Evaluation of California Water Fix Groundwater Modeling

CA Water Fix Proceeding

Exhibit SCWA – 205

Petitioners' Rebuttal Re: Alt 1B

Comparison of the water budget components in the No Action Alternative (NAA) and the Alternative 1B scenarios correspondent to the South American Subbasin

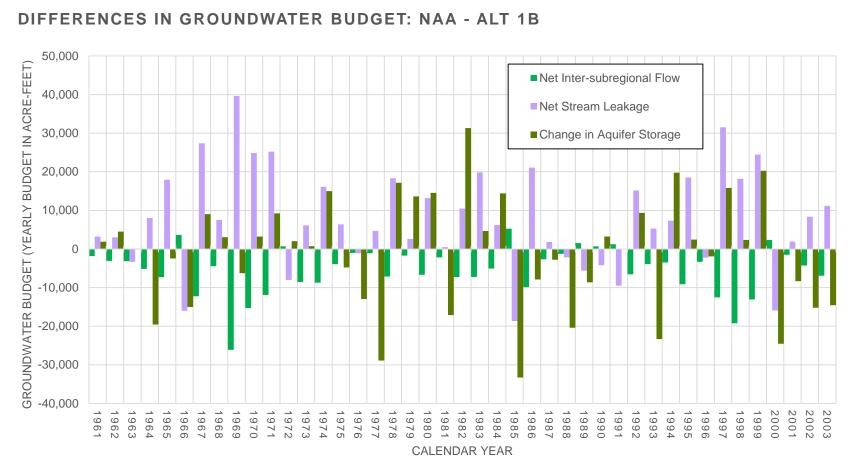
-The CVHM-D NAA & Alt1B scenarios exceed the 1% budget error threshold 57% and 59% of the time, respectively

-Simulations with discrepancies between inflows and outflows greater than 1% indicate issues with model precision and/or design, and the reliability of the results scwa-205

Modeled differences in hydraulic head between NAA and Alternative 1B

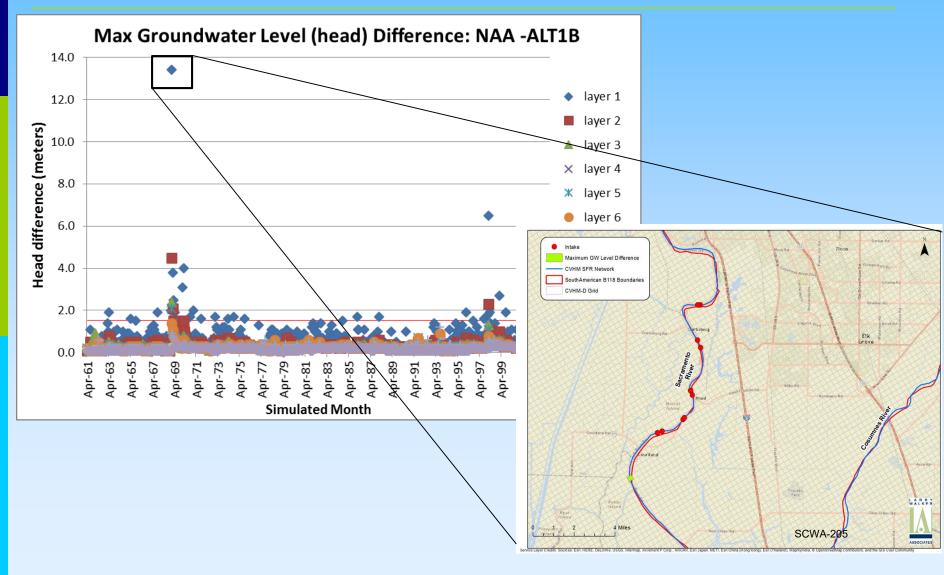
-Maximum difference of approximately 44 feet

- -Head differences larger than 5ft occur 34 times throughout the simulation period
- -Cited differences are within the noise of the model and thus have questionable reliability

Testing different convergence criteria

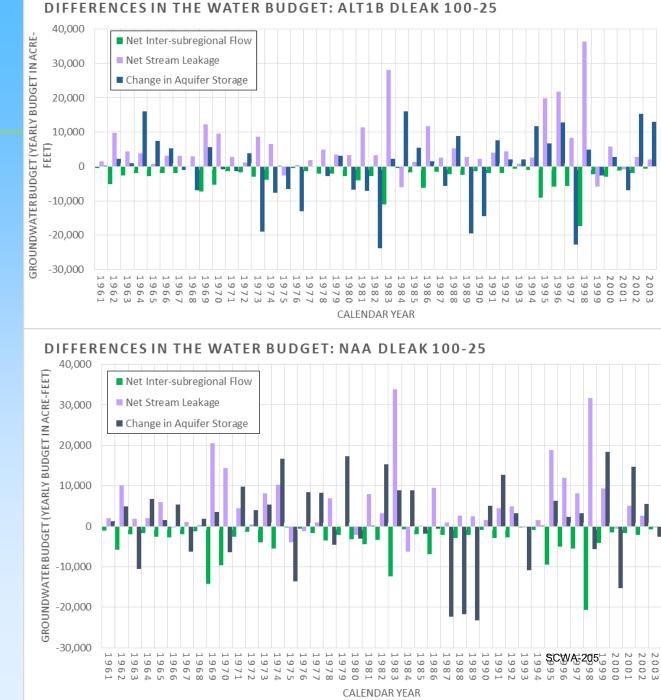
- Substantial number of budget errors exceeding the standard threshold of 1% and the large head differences in 1969 and 1998 indicate numerical instabilities in the model and call into question the reliability of the simulated results
- I checked the closure criteria (precision to which the CVHM-D model is simulated) used for heads and river discharge, which can cause the budget convergence issues mentioned above
- The closure criteria used in the CVHM-D model is much larger than what is recommended, which can compromise the fidelity with which the model can simulate stream/aquifer interactions.

Cumulative Difference in Sac. River Leakge Volume in S. Am. Subbasin: CVHM-D NAA-Alt1B

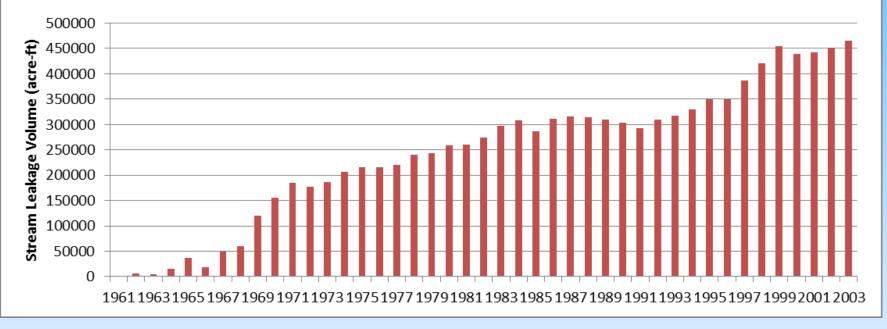
-Given the evidence in the record indicating the Sacramento River serves as a source of recharge to the Central Basin (Zone 40), it is possible that this significant cumulative change in stream leakage could adversely affect Zone 40 groundwater resources
